**RE: PERFORMANCE AUTO MALL – SPECIAL USE PERMIT**

**PERFORMANCE SITE PLAN - RESPONSE TO COUNCIL AND CDC COMMENTS AT CONCEPT PLAN REVIEW**

Figure 2

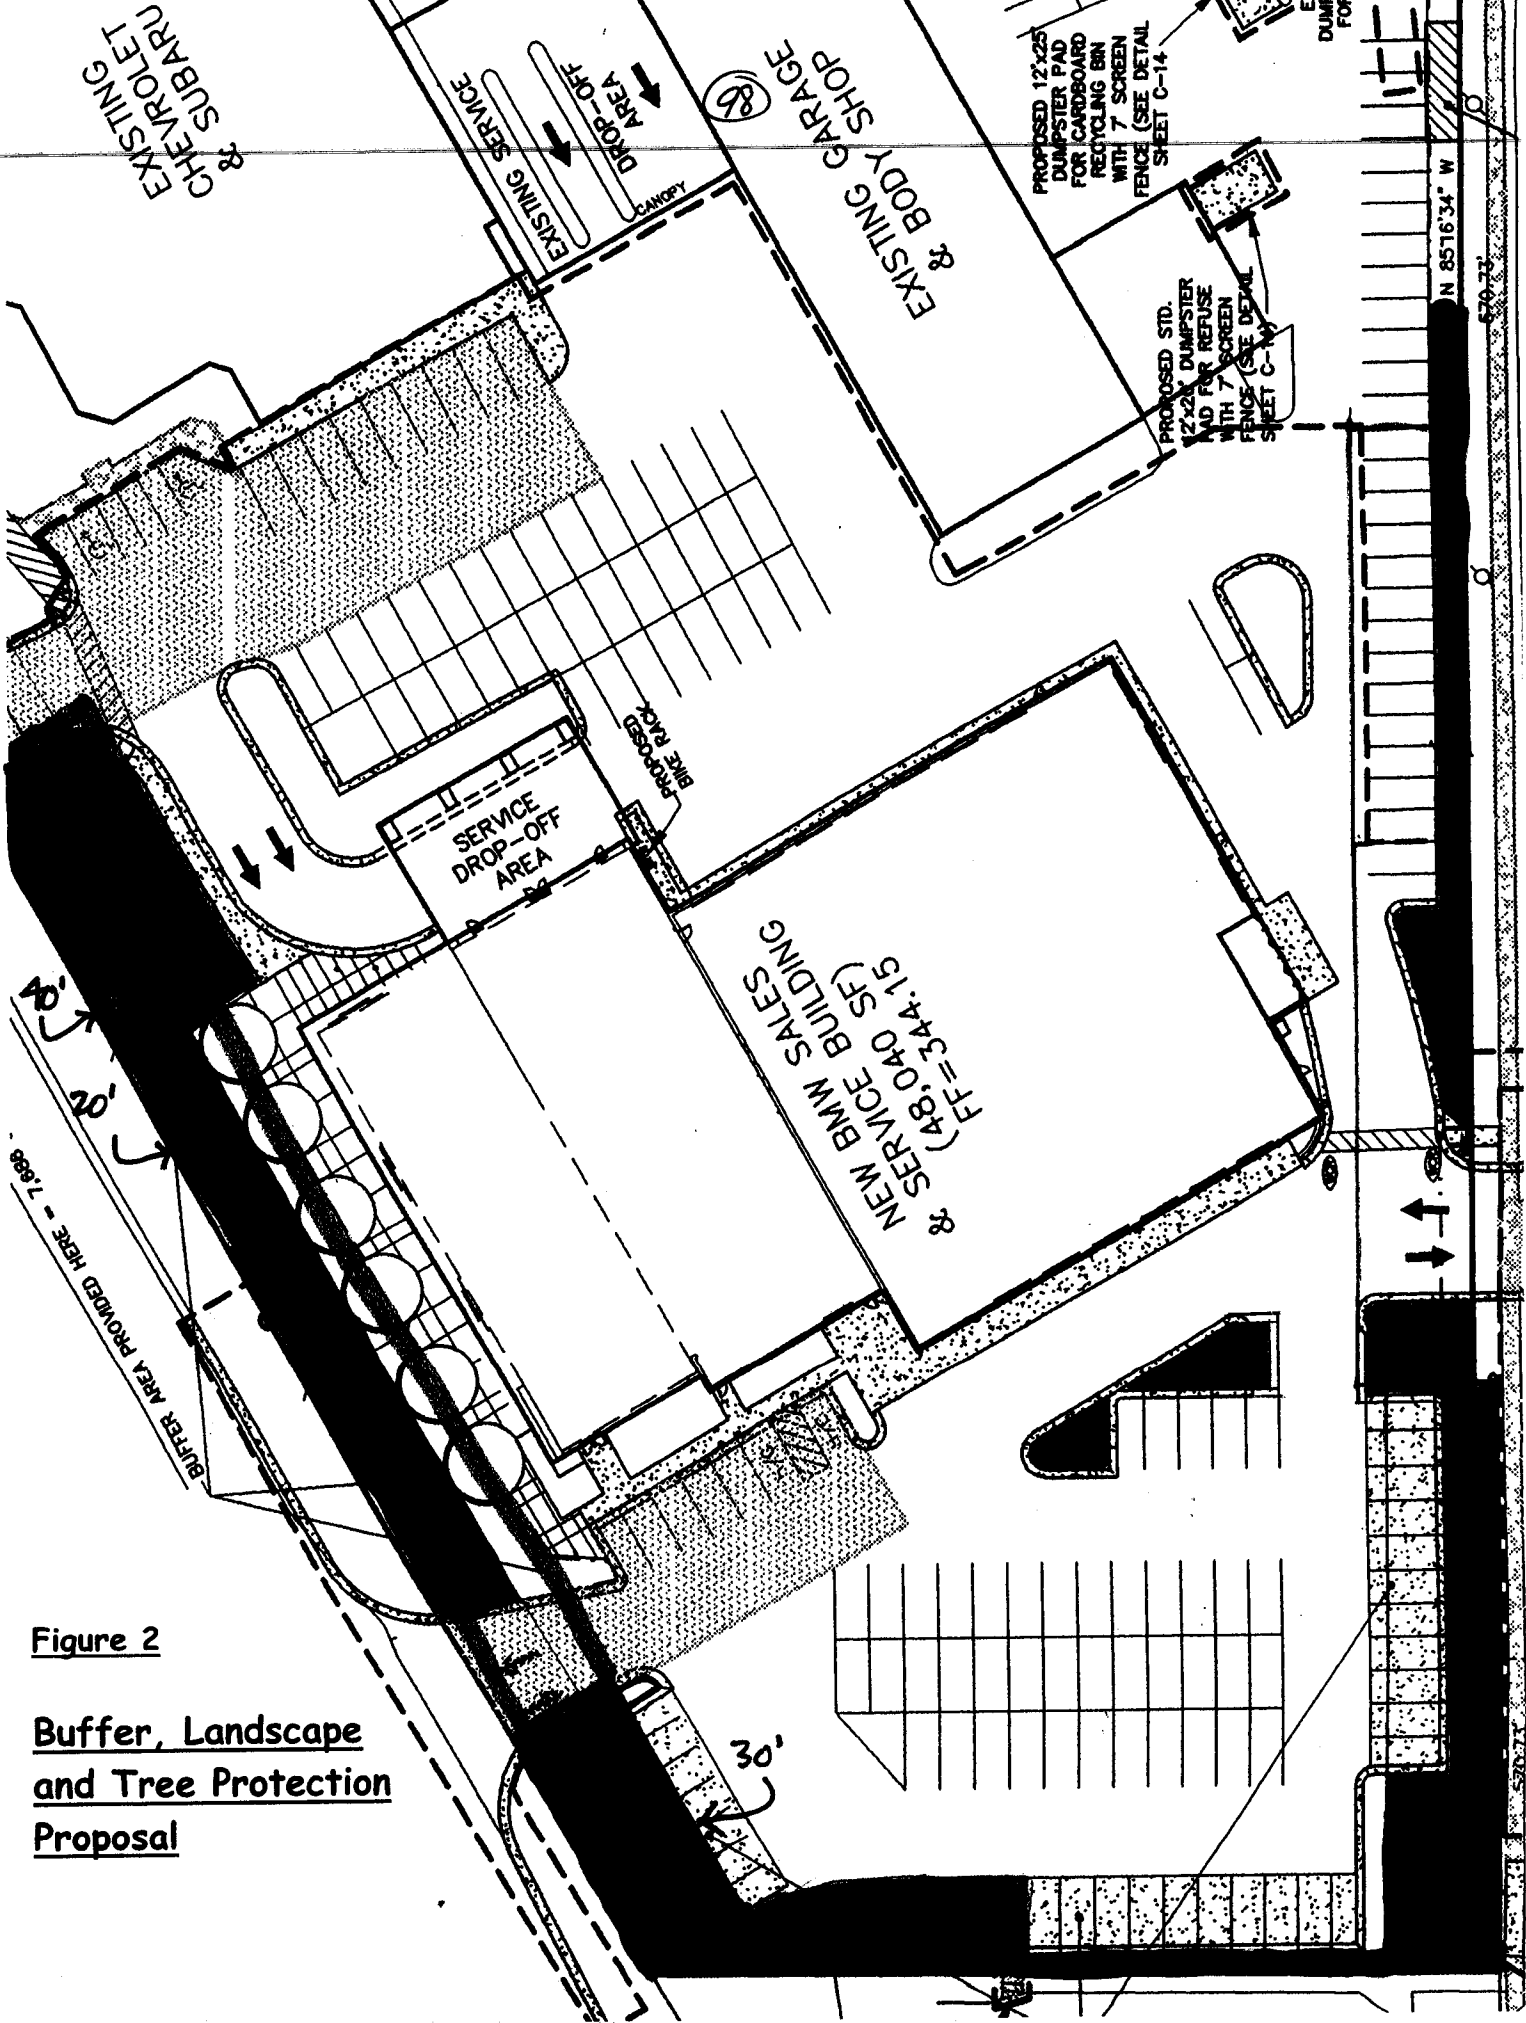
I suggest that alternative buffers as described below and shown on Figure 2 be considered.

A) Buffer along US 15-501 Service Road

- A 30 feet buffer as required by the LUMO to the west of the entry drive serving the new BMW Sales and Service Building.
- A 40 feet buffer as offered by the Applicant (and shown on the submitted plans) to the east of the new BMW Sales and Service Building.
- A 20 feet alternative buffer in front of the new BMW Sales and Service Building.

B) Buffer along Old Durham Road

- The alternative buffer proposed by the applicant with 2 modifications:
  1. The expansion of the buffer at the entrance from Old Durham Road by removing 2 of the proposed parking spaces and increasing the area for landscaping, and
  2. Enlarging the interior planting island immediately inside this entrance by removing 1 parking space thereby improving the traffic flow and safety of the entrance and the drive aisle.

I believe the changes shown on Figure 2 are modest in area, but significant in visual impact. And, as stated earlier, I believe that if the applicant is required to provide a full 30 feet buffer on both Old Durham Road and on the Service Road that it will force a redesign of the site that will inadvertently – but surely – push the applicant toward the original Concept Design that neither the Council nor the CDC liked.
